## ROTAX 582 UL DCDI — marking of pick-up

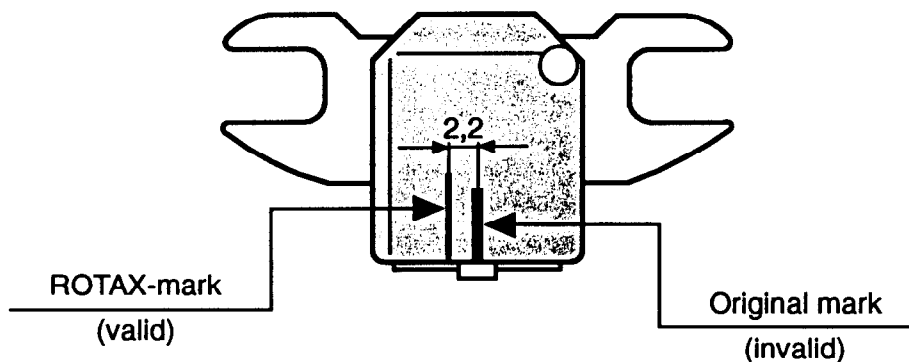
Because of the incorrect marking by our supplier all the pick-ups (part-no. 965 760 and 965 767) had to be marked supplementary.

This mark is placed 2,2 mm beside the erroneous original marking (see sketch).

At an ignition timing check the supplementary mark of the pick-up has to be in line with the mark on the flywheel.

◆ NOTE: Pick-ups have to be fitted with a gap of  $0,5 \text{ mm} \pm 0,05 \text{ mm}$  to the trigger bar on flywheel.
